Sheet: /		
File: EthernetBoard.sch		
Title: 96Boards Mezzanine Project Template		
Size: A4	Date: 14 Aug 2015	Rev: A
KiCad E.D.A. kicad 5.1.5-52549c584ubuntu18.04.1		Id: 1/5

Sheet: /IO_Extension/
File: IO_Extension.sch

Sheet: /Connectors/ File: Connectors.sch		
Title:		
Size: A4	Date:	Rev:
KiCad E.D.A. kicad 5.1.5-52549c584ubuntu18.04.1		Id: 2/5

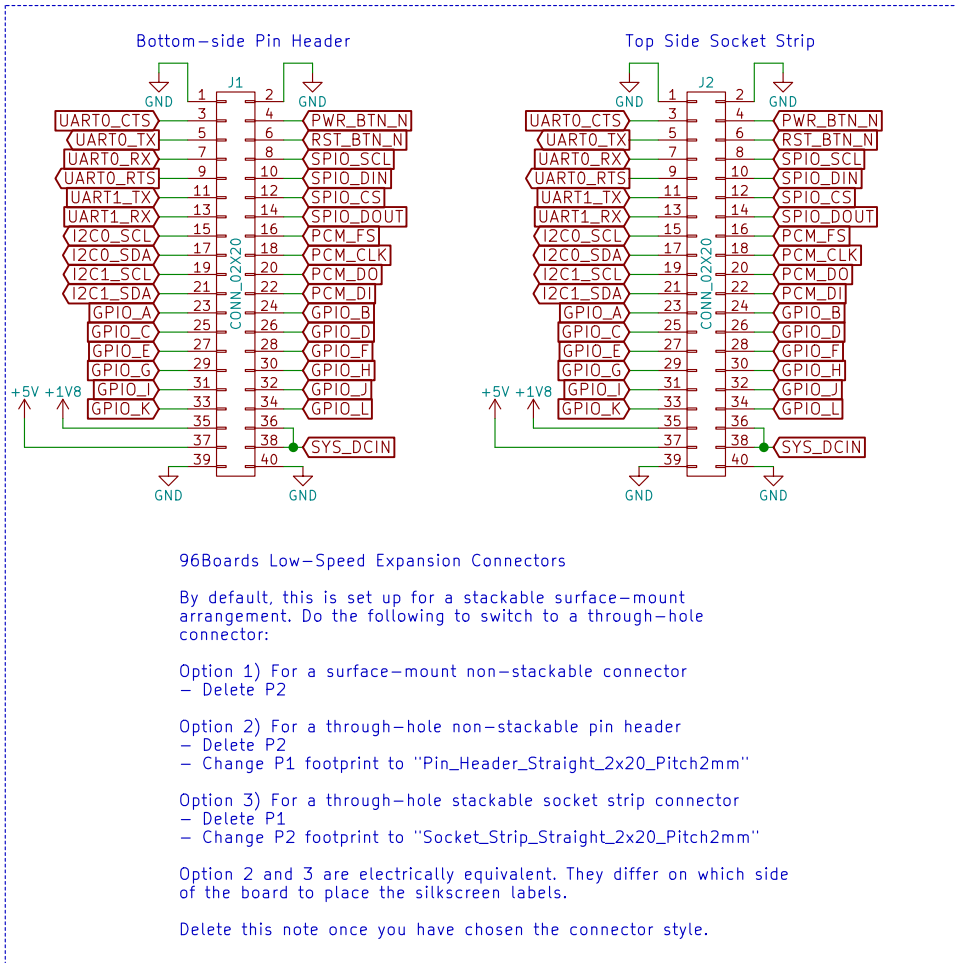
Part Name: Tesi5xxuc-evb
(Universal Oscillator Evaluation Kit) used 1.1uF for C41.
Did not reflect on here this time.

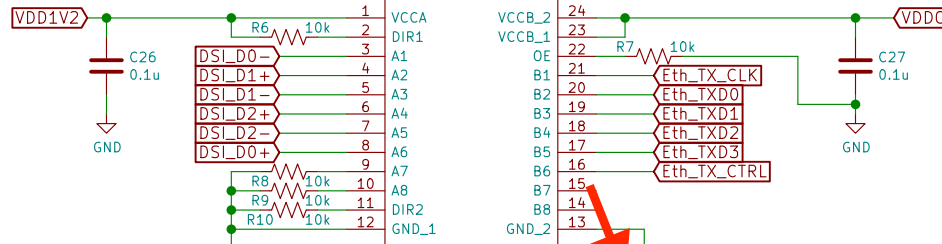
L1: 64uH~180uH can be used. However, higher value often increase DCR as well. Need lower DCR!
DCR:100uOhm~330mOhm. IDC 825mA~16A.
Below values give 88% efficiency for U8.

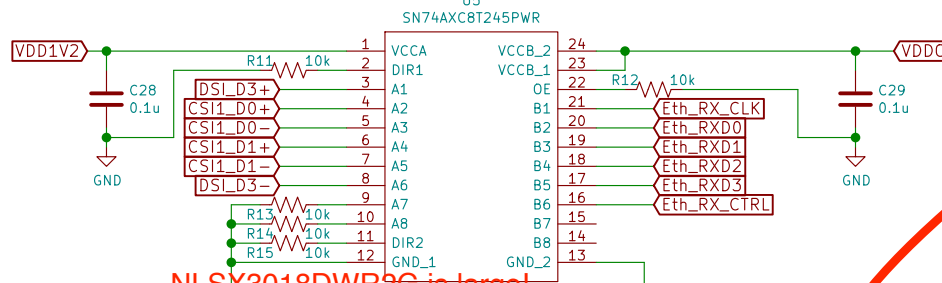
This translator must not have any floating pins

NLSX3018DWR2G is large!
NLSX3018DTR2G should be used.

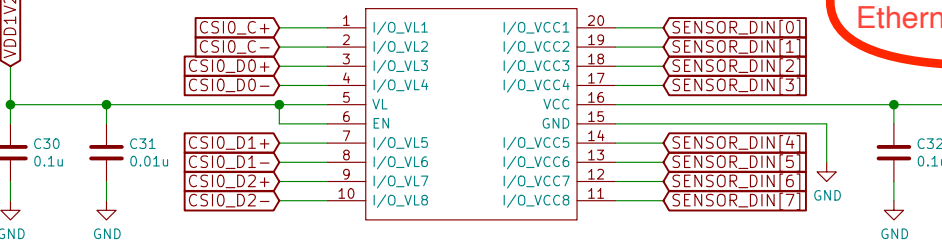
DTR2G is out of order, hard to find the vendors

Cin (C24): keep 4.7uF

L2: 2.2uH (2.2~2.7uH, higher better...)
lower DCR gives higher efficiency, DCR: less than 260mOhm, IDC: 0.6A~10A

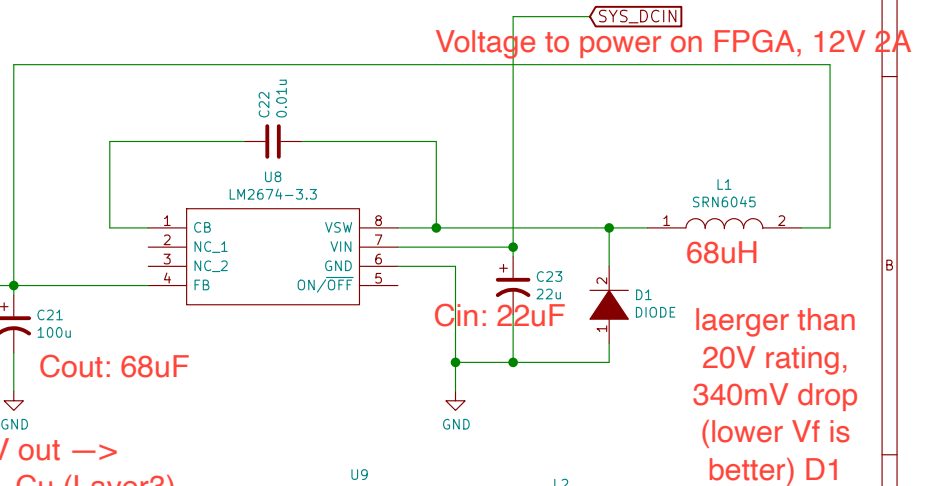
Application note says that VCC and VDD1V2 for U6 and U7 must be decoupled with capacitors, recommend values are 0.01uF to 0.1uF. Current schem used 0.11uF...

Cout: 68uF

laerger than 20V rating, 340mV drop (lower Vf is better) D1

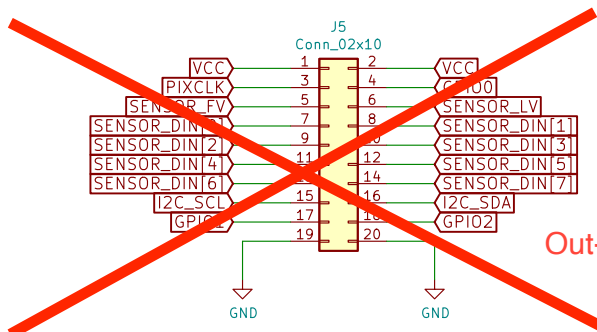
Cout (C25): any capacitor 10uF~100uF work, no change on efficiency, only inductor matters

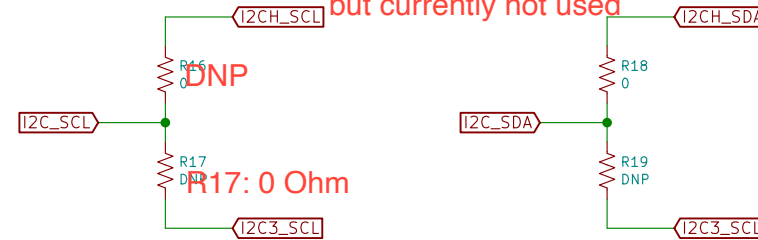
These circuits look like for extra signal communicator for FPGA and external signals, but currently not used

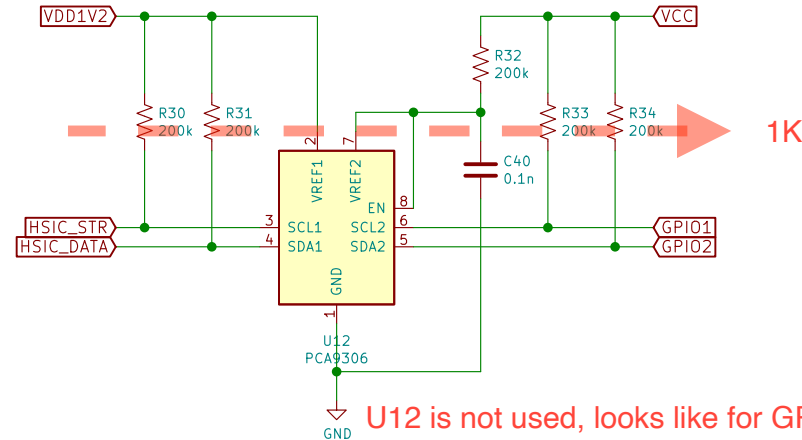
U10 is not used, looks like extra signal communicator for FPGA and external signals

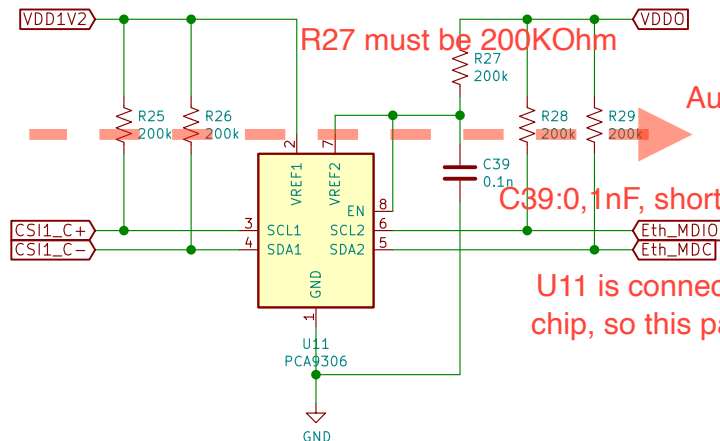
U12 is not used, looks like for GPIO TTL out from FPGA

R27 must be 200KOhm

Author used 1K Ohm, however, these pull up resistor should be carefully calculated depending on each side voltage and current driver sink!

C39:0, 1nF, shorting or any small values are fine.

U11 is connected to ethernet chip, so this part is important!
